The following drawing index sheet and reference drawings have been added to Volume 3.

DESIGN OF NEW STAIR FOR BETHESDA STATION - CONTRACT NO. 13-FQ1 0060-MCAP-19

RED LINE REHAB.-FRIENDSHIP HEIGHTS TO GROSVENOR - PART 6
PHASE 1B SECTIONS
SCALE AS SHOWN
DRAWING NO. A09-A-301
SHEET NO. M1272-195

1
G-101
EXISTING CABLE TEMPORARY PROTECTION DETAIL
SCALE: 1/2" = 1'-0"

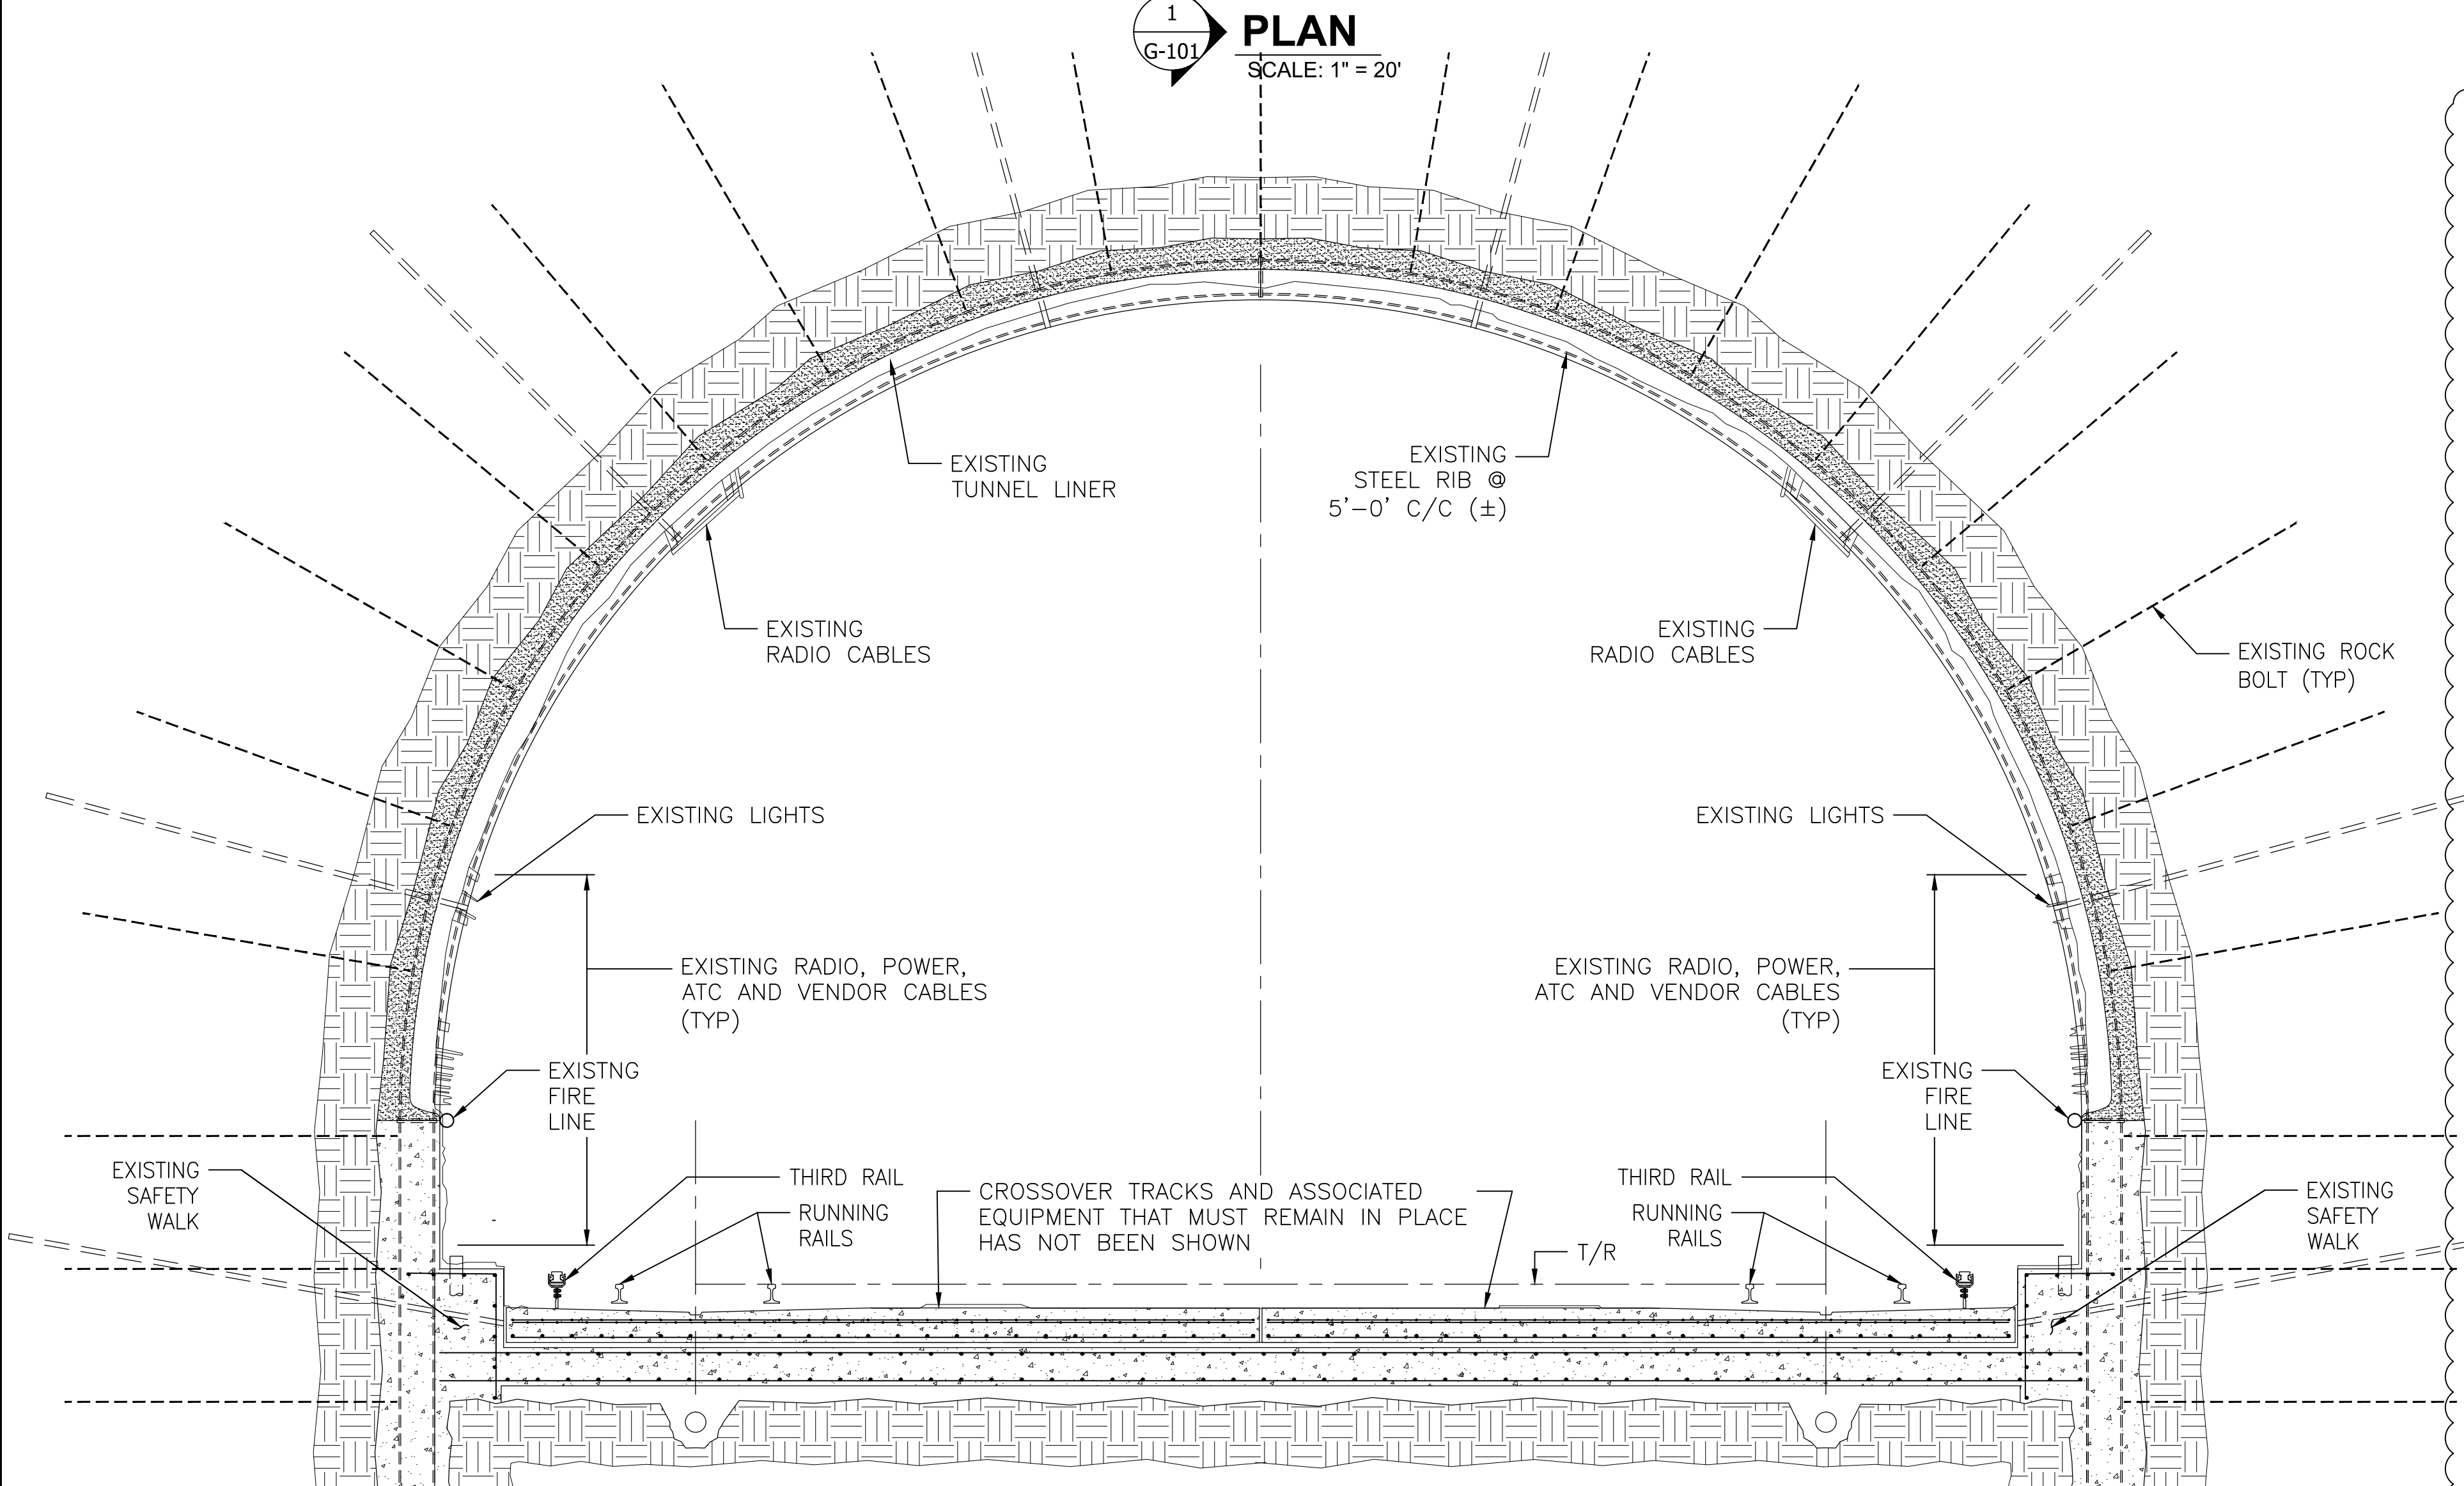
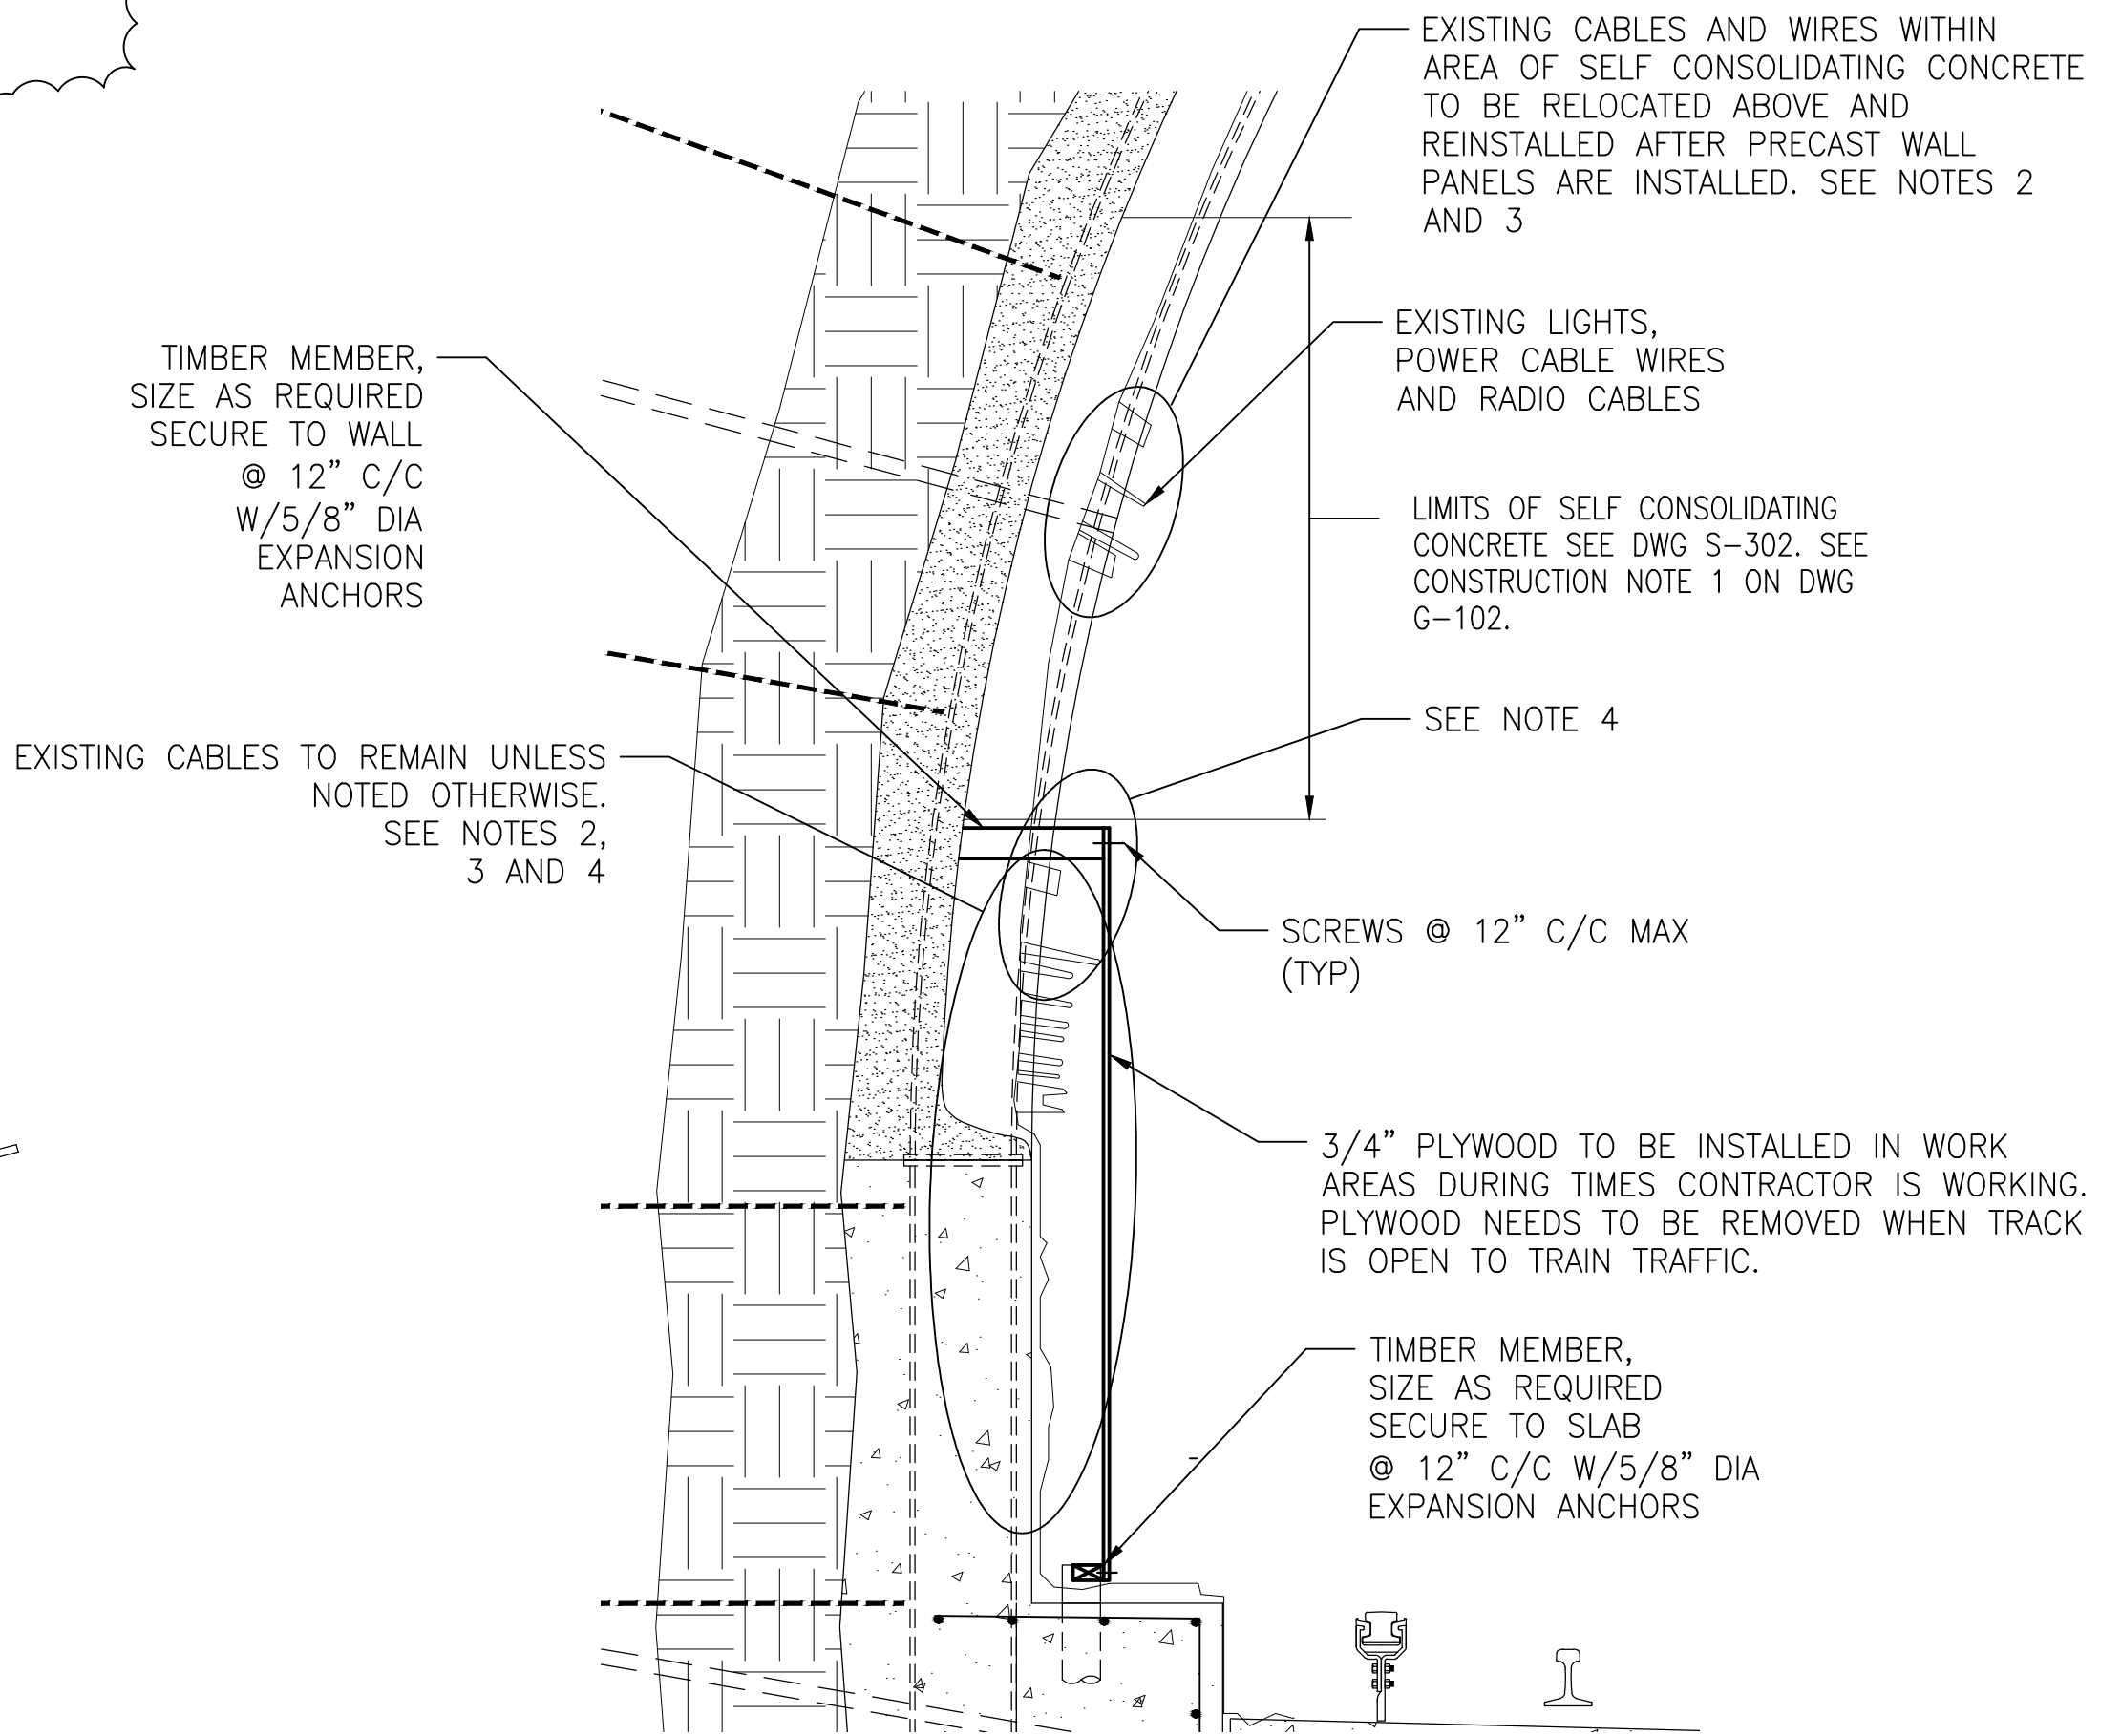
DESIGNED		DATE		REFERENCE DRAWINGS		DATE		REVISIONS	
NUMBER	DESCRIPTION	DATE	BY	NUMBER	DESCRIPTION	DATE	BY	DESCRIPTION	DATE
01-15	M. VADOVIC	01-15	VC			06-15	VC	ADDED TEMPORARY EXISTING CABLE DETAIL	AM 2
01-15	P. GRUBB	01-15							
01-15	V. CECKA	01-15							
01-15	M. AVERSO	01-15

- NOTES:
- CONTRACTOR IS RESPONSIBLE FOR PROTECTION OF EXISTING CABLES DURING WALL WORK. RECOMMENDED DETAIL IS SHOWN ABOVE. 3/4" PLYWOOD TO BE INSTALLED WHILE CONTRACTOR IS WORKING ON THE WALL ABOVE. PLYWOOD NEEDS TO BE REMOVED WHEN TRACK IS OPEN TO TRAIN TRAFFIC. CONTRACTOR MUST TAKE PRECAUTIONS DURING ALL HIS OPERATIONS NOT TO DAMAGE EXISTING CABLES.
 - SEE PICTURE 1 AND PICTURE 2 FOR GENERAL VIEW OF EXISTING WALLS.
 - SEE ELECTRICAL DRAWINGS FOR PART 1 AND 2 FOR ADDITIONAL INFORMATION. SEE EXISTING REFERENCE DRAWINGS A10-E-100, A10-E-611, A-10-E-612, A10-E-613, A10-E-614 AND A10-E-620 DATED 03/13 FOR ADDITIONAL INFORMATION.
 - CONTRACTOR TO MOVE DOWN AND GROUP CABLES (SEE REFERENCE DRAWING A10-E-611 AND A10-E-613 FOR CABLES) TO BELOW TOP OF OPENING IN PRECAST WALL PANEL IF CABLES ARE LOCATED ABOVE TOP OF PRECAST WALL PANEL OPENING.
